**COUNTY OF WESTCHESTER
NEW YORK**

ADDENDUM NO. 3

CONTRACT NO. 20-502

**LOW RISE BUILDING RENOVATIONS AND
HVAC IMPROVEMENTS - PHASE II
110 DR. MARTIN LUTHER KING, JR. BOULEVARD
WHITE PLAINS, NEW YORK**

6 WOMEN'S RESTROOM SIGN - S6
6" = 1'-0"

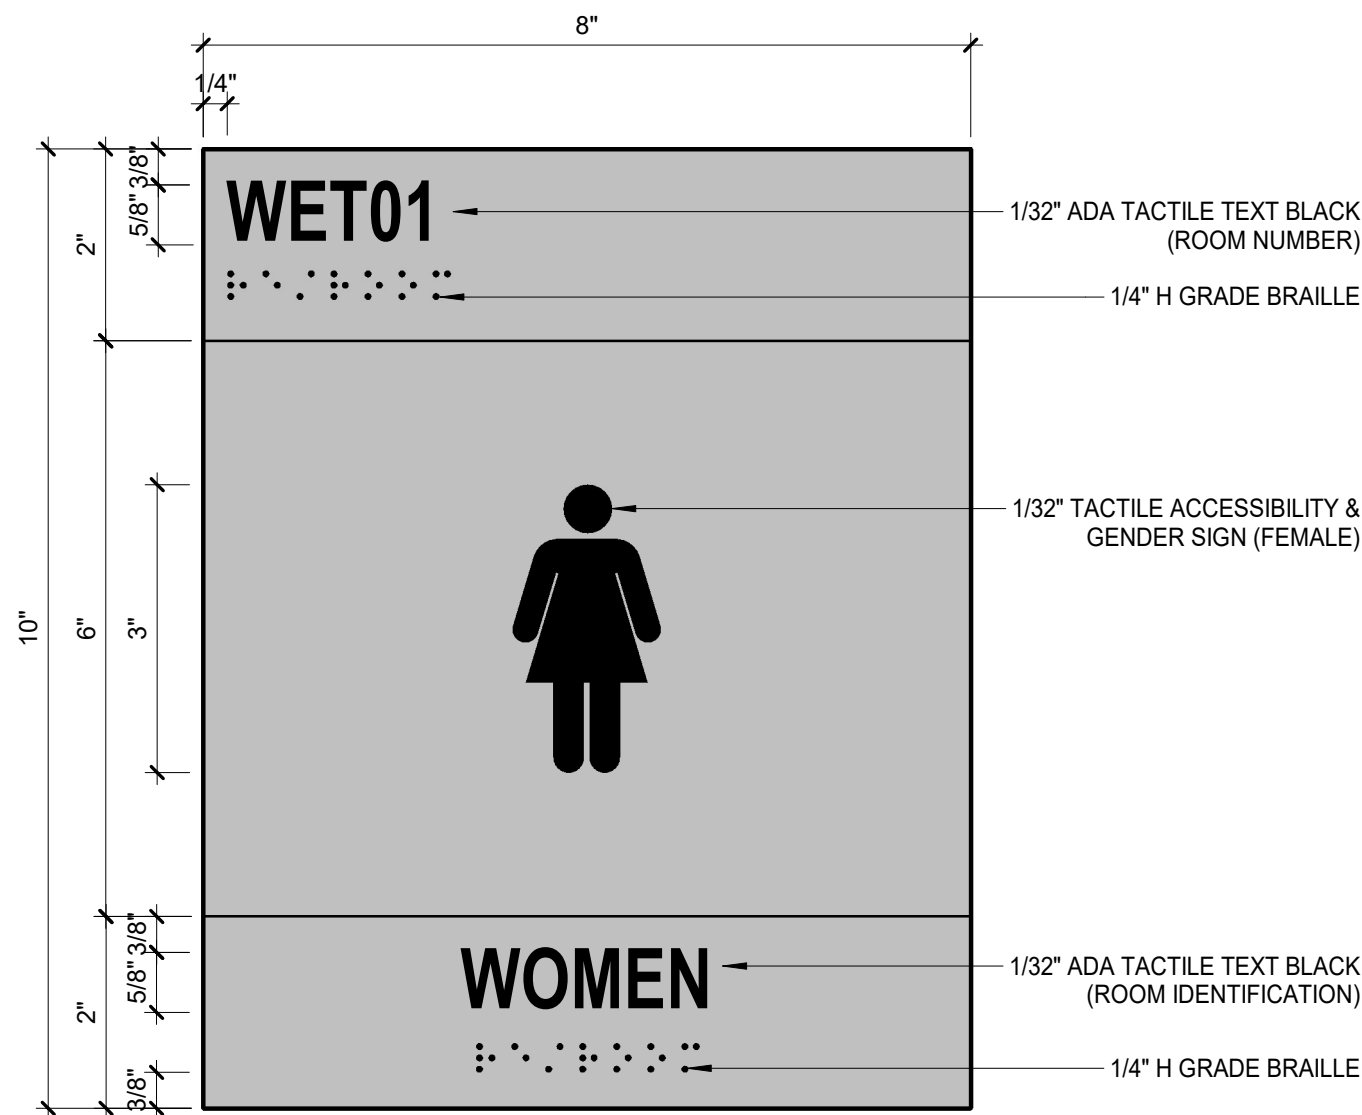
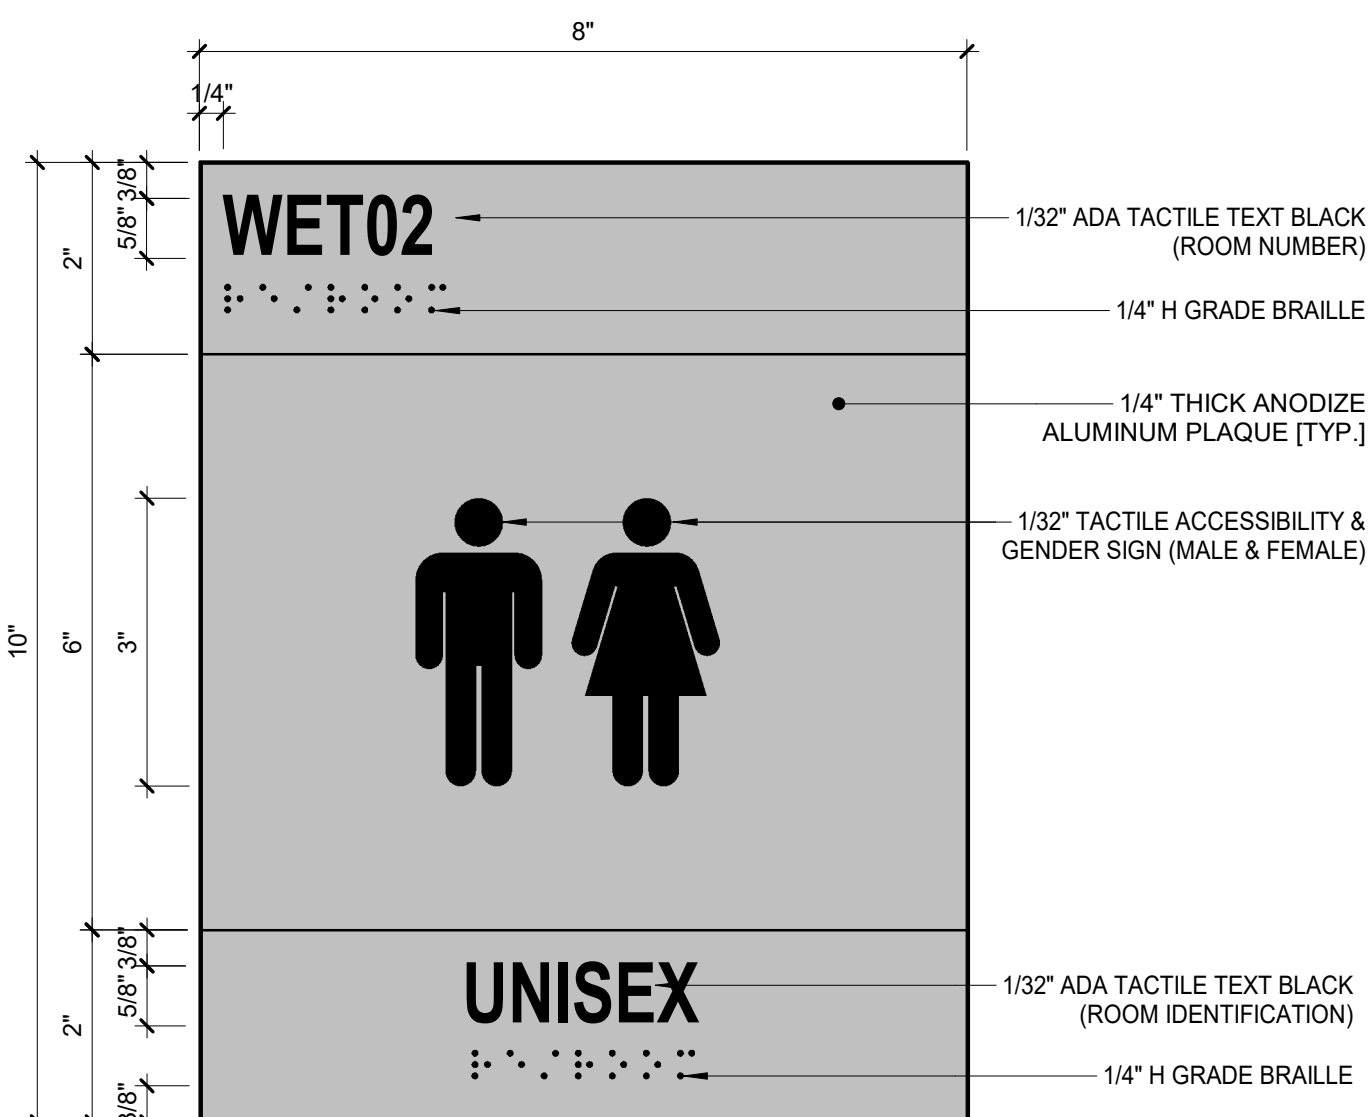
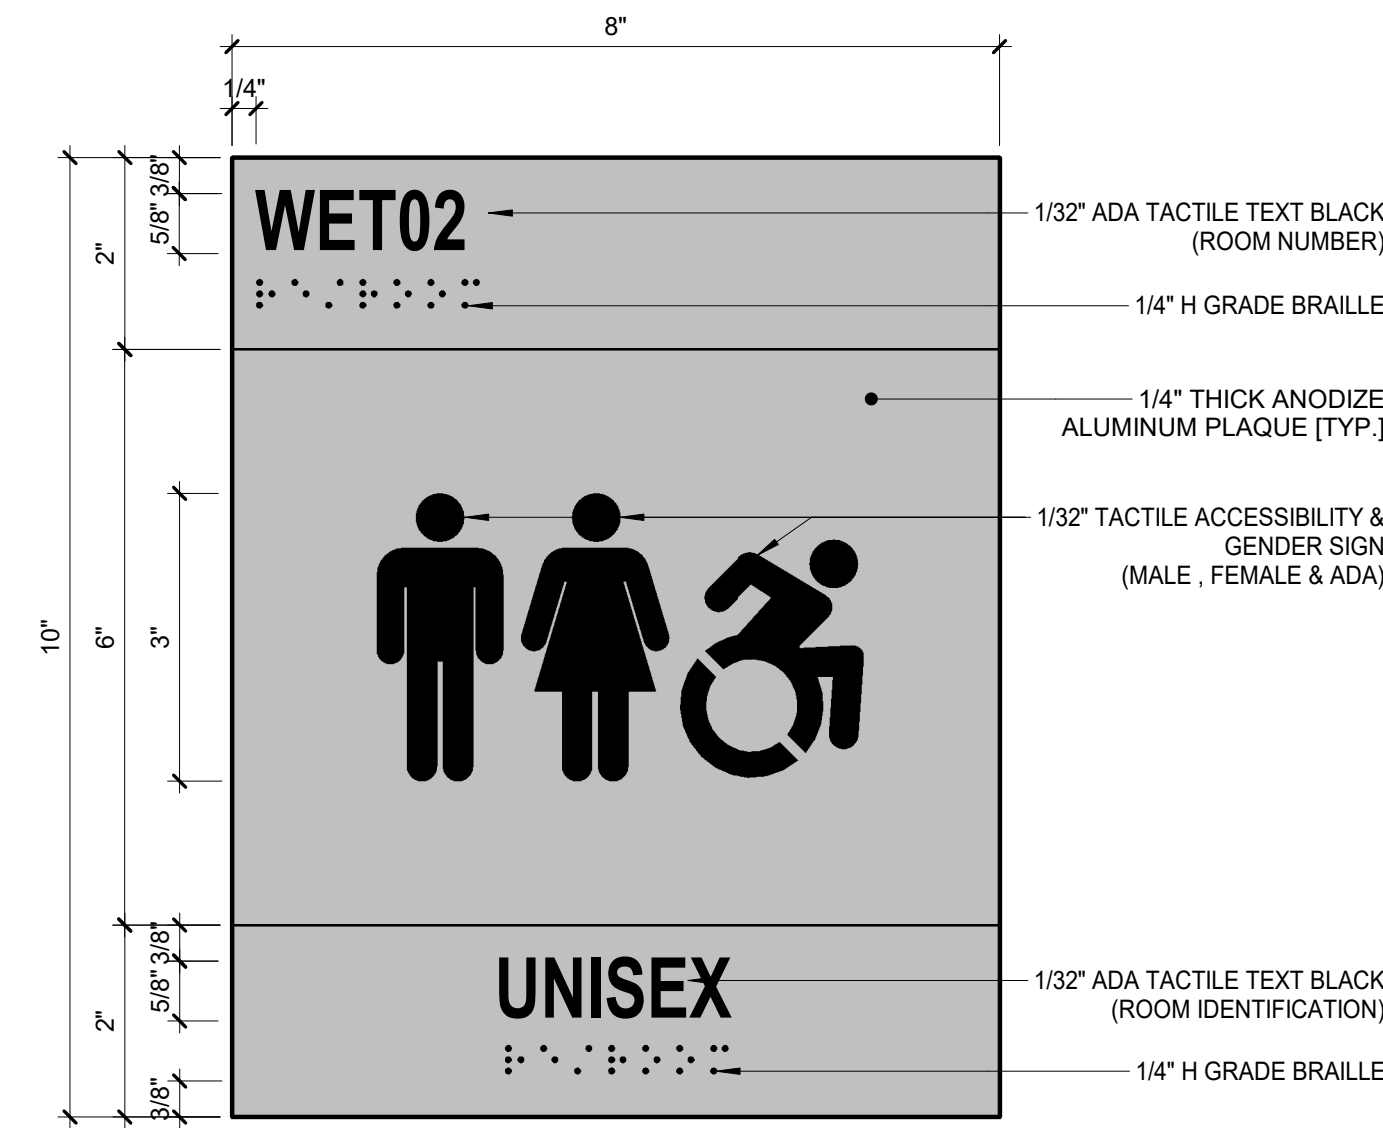
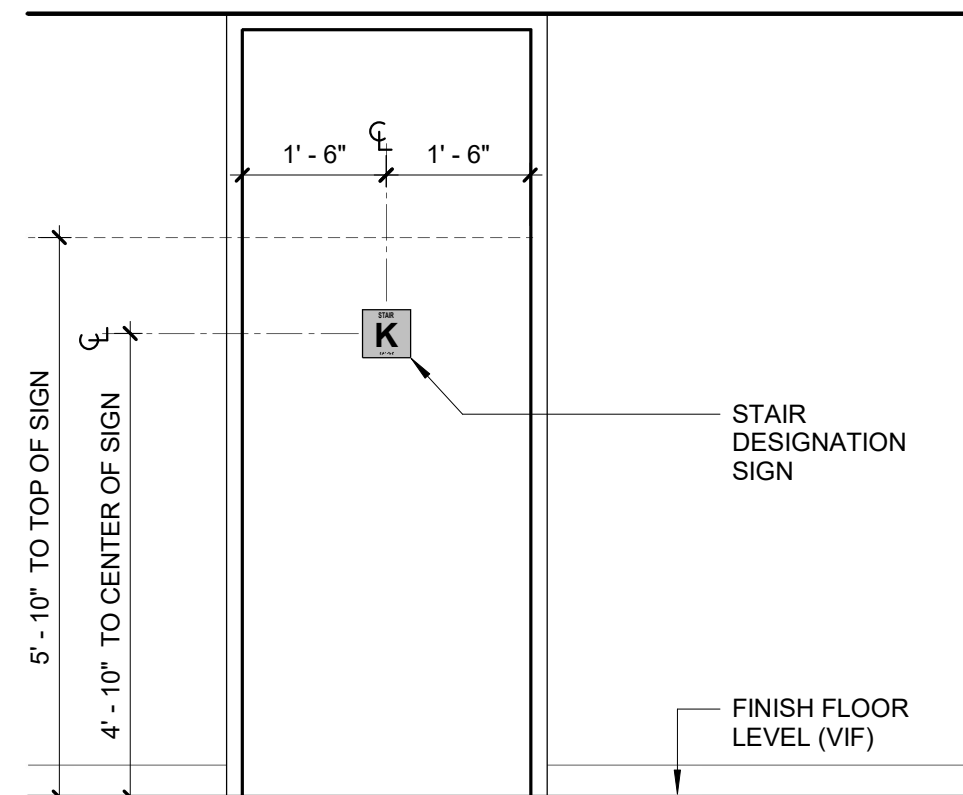
| Q16 | How many signs of each type are we to include Ref. DWG. A-303, signage schedule Please provide a signage schedule. | <p>Refer to drawings issued as part of Addendum #3 Please find revised finish plans, A-111 through 114 and signage details on A-303. Signage symbol S-# has been added on finish plans. Signage type, details, note, etc. have been modified on A-303.</p> |

<table><tr> <td style="width: 50%; padding: 5px;"> CONTRACT NUMBER 20-502 </td> <td style="width: 50%; padding: 5px;"> SHEET NUMBER E-204 </td> </tr></table>

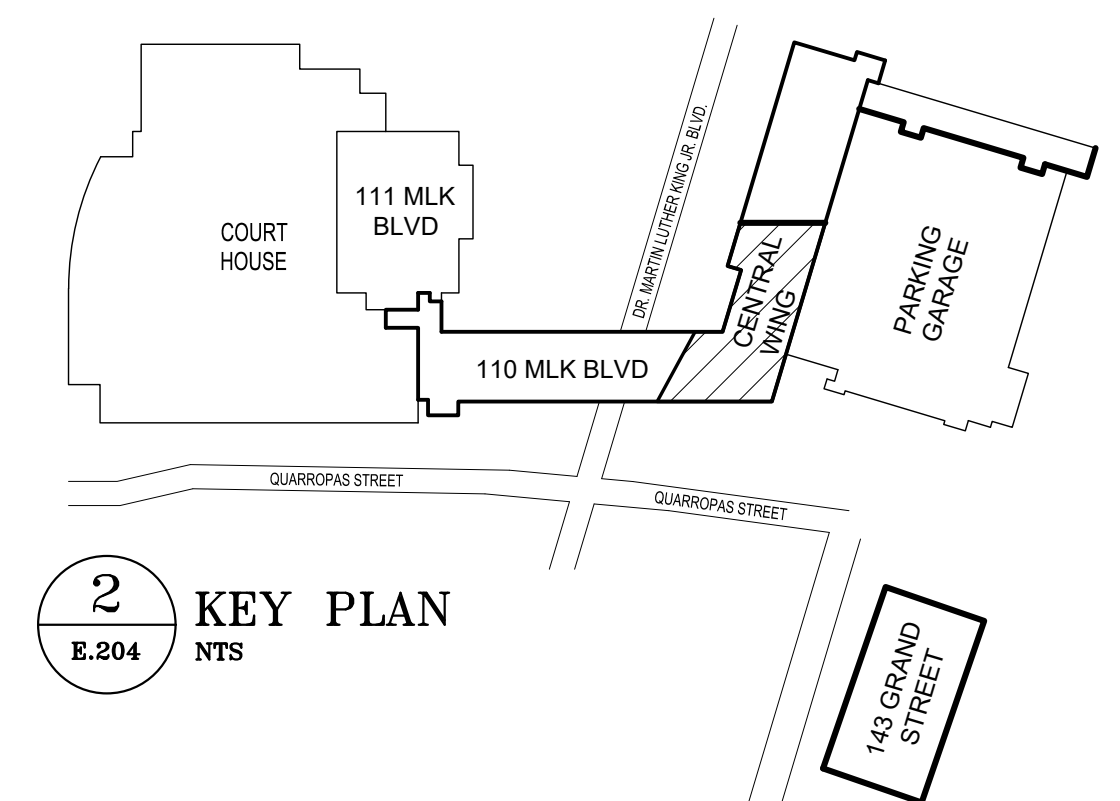
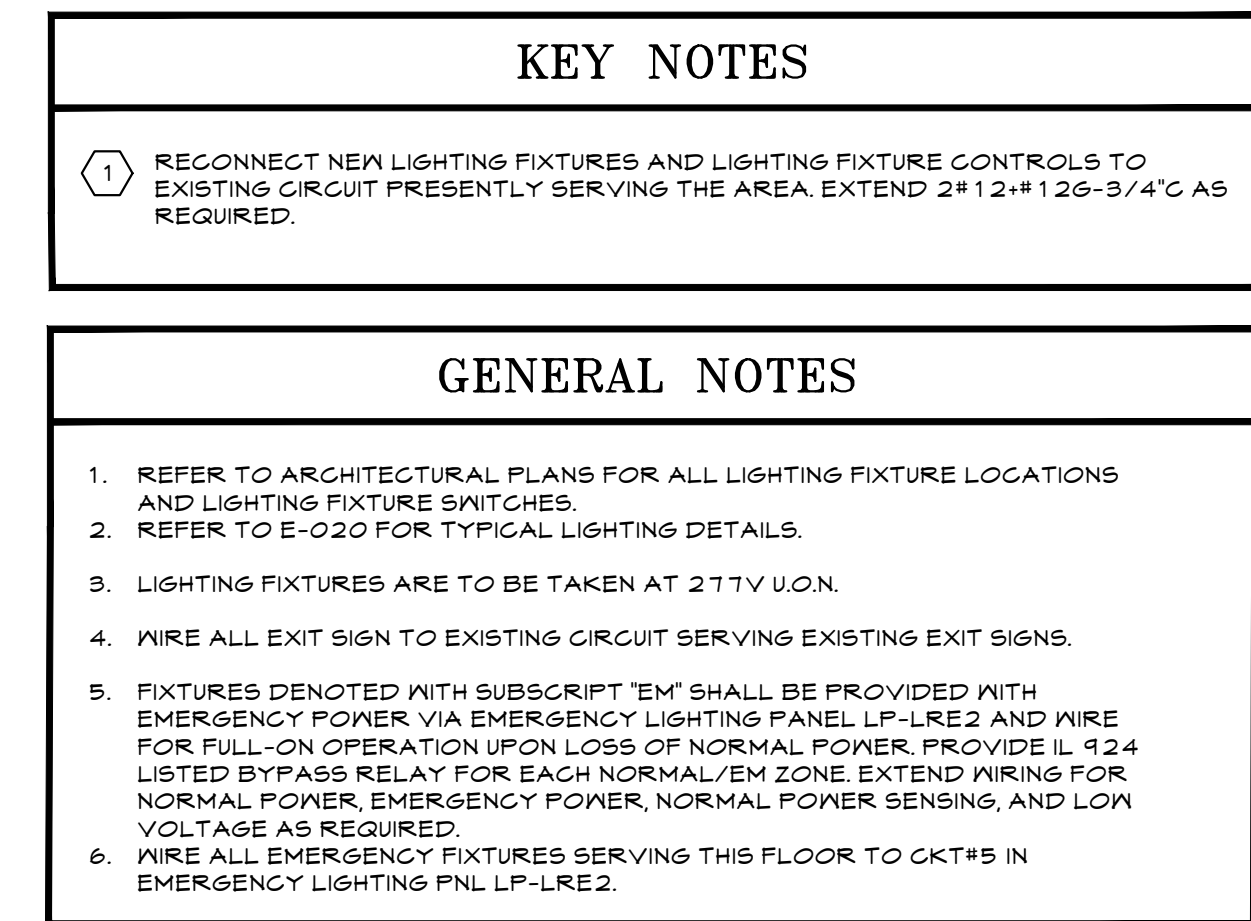
| No. | Contractor Question | Answer |
|------------------------------------|-------------------------------------------------------------------------------------------------------------------------------------------------------------------------------------------------------------------------------------------------------------------------------------------------------------------------------------------------------------------------------------------------------------------------------------------------------------------------------------------------------------------------------------------------------------------------------------------------------------------------------------------|-----------------------------------------------------------------------------------------------------------------------------------------------------------------------------------------------------------------------------------------------------------------------------------------------------------------------------------------------------------------------------------------------------------------------------------------------------------------------------------------------------------------------------------------------------------------------------------------------------------------------------------------------------------------------------------------------------------------------------|
| Q32 | <p>The Electrical Drawing E-204 shows light fixture "F4" in the bathroom next to the elevator shaft. However, the light fixture schedule on Dwg A-304 does not include "F4". Please, provide manufacture information for "F4" light fixture.</p> | <p>Refer to drawings issued as part of Addendum #3</p> |
